STAFF REPORT: 03/12/2025 REGULAR MEETING

APPLICATION NUMBER: HDC2025-00093

ADDRESS: 9851 HAMILTON

SCOPE: CONSTRUCT PARKING LOT AND TRASH ENCLOSURE

Figure 2. Proposed site plan, showing trash enclosure and concrete parking area.

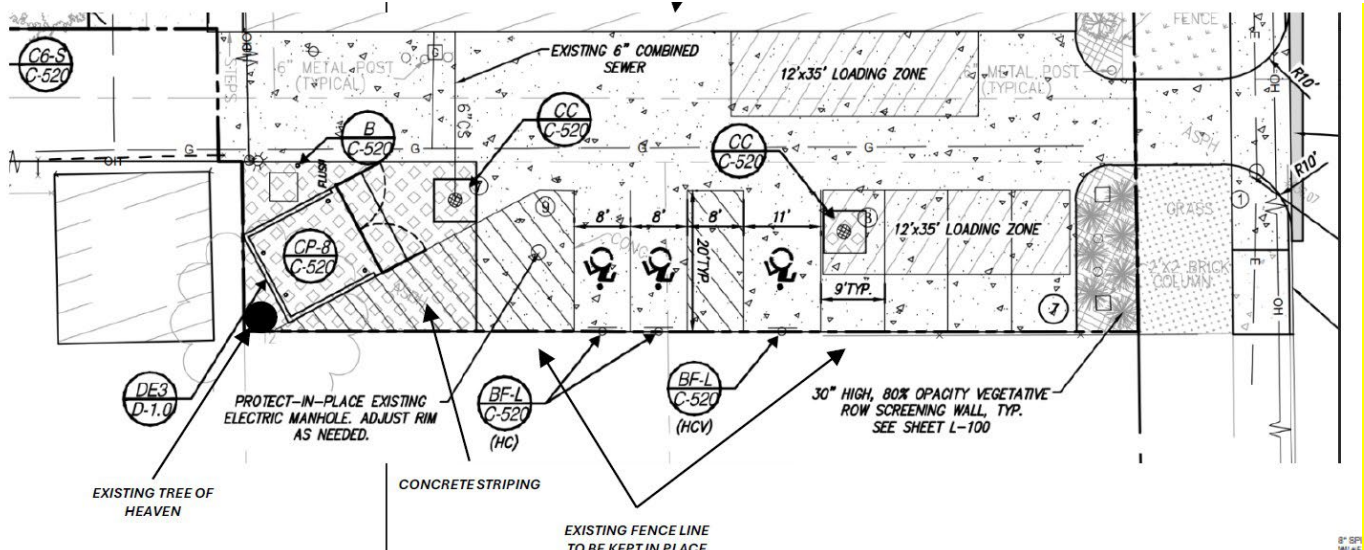
- Staff requested the following information, which has not been received at the time of this report:
 - Height of the trash enclosure.
 - Confirmation on retention of the existing 3 brick columns.
 - Confirmation on species of what appears to be a proposed evergreen planting along side the entrance the parking lot.

Figure 5, by applicant: Dumpster enclosure elevations and axonometric showing CMU wall with option to add brick cladding to match the building (optional) and aluminum gate.

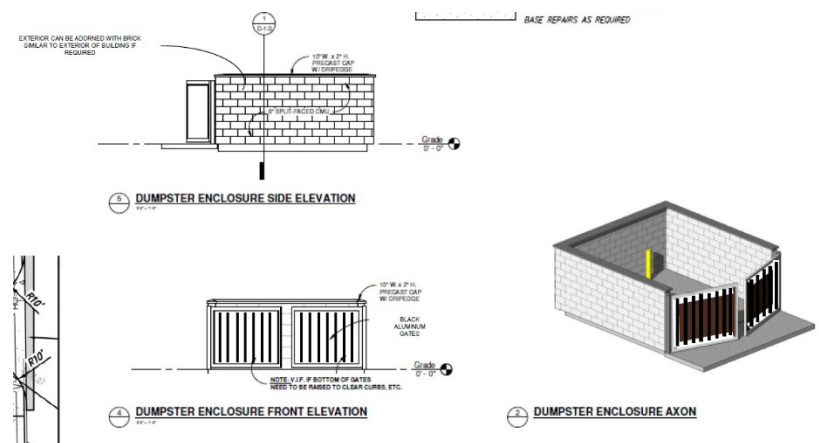
- The application states that the proposed trash enclosure shall be “split-faced CMU” with an alternate to add brick cladding to match the building. Staff observed that CMU is present in the alley with a garage, such as the one located in the 1140 W. Boston alley. However, staff observed that this garage received a Certificate of Appropriateness with the condition that staff review the proposed brick cladding, which is not currently present. It is staff’s opinion that due to the public visibility of this trash enclosure and because it is located within the series of garages in the alley with brick cladding as an intended material, the brick cladding option (to closely match the building) should be applied to a potential approval of this proposal. (See Appendix B for details on the 1140 W. Boston COA, figure 5 and site photo 3.)

- With the exception to the use of CMU material for the enclosure, staff has no issue with the material and design of the parking area. Staff recommends cladding the enclosure with brick compatible with the existing building and to be consistent with the Boston-Edison Elements of Design.

- Brick cladding compatible with the building is used on the trash enclosure and will be submitted for review by HDC staff.
